Subject: MDEQ Detailed Comments_Kalamazoo River_OU5_Area 6 SWWP 03292018

SUBJECT: Michigan Department of Environmental Quality (MDEQ) Comments for

Operational Unit 5 (OU5) Allied Paper, Inc./Portage Creek/Kalamazoo River Superfund Site, Area 6 Surface Water Work Plan (Work Plan), dated March 29, 2019, Prepared by Wood Environment and Infrastructure Solutions, Inc.

Kalamazoo River Superfund Site Area 6 Surface Water Work Plan March 29, 2019

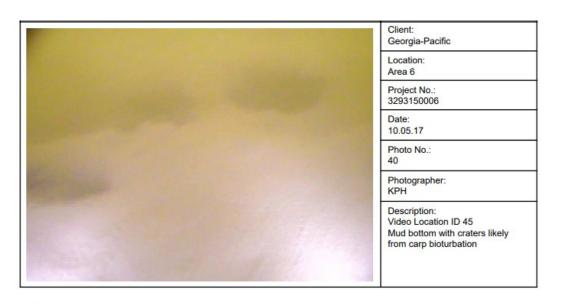
Specific Comment #14: The "evidence of bioturbation" should be further explained, including if this evidence was used to evaluate monitoring locations presented in the Work Plan. Lakebottom environments may be more dynamic than suggested in the text. For example, in deeper lake bodies, surficial wave action is driven by wind currents but return currents moving in an opposite direction may be present deeper in the water column.

The 2017 Area 6 Video Condition Survey Report provided to the MDEQ shows what appears to be gravitational settling (loading) or perhaps *lingoid* or *lunate ripple marks*, which would be bedform features unrelated to bioturbation, but the quality of the video is such that the identity and cause of the feature(s) cannot be determined.

In 2015, the MDEQ collected images of lake-bottom sedimentary features that appear similar to those provided in the Area 6 Video Conditions Report, in a lake (Torch Lake) that is void of carp (0 to <0.1 catch per unit effort [The Fish Community and Fishery of the Portage-Torch Lake System, Houghton County, Michigan in 2007-08, dated June 2016]) and at the exact depth

referenced in the text. Those images were shared with GP via email on March 26, 2019 and are provided below.

While the identity and cause of the lake-bottom features observed in Lake Allegan is debatable the assertion that they are the result of carp feeding or other biological activities related to carp (or other bioturbating organisms) should be made with caution without additional lines of evidence to support that claim, particularly if these lake-bottom features are being used to justify placement of HyST or OPTICS monitoring platforms.
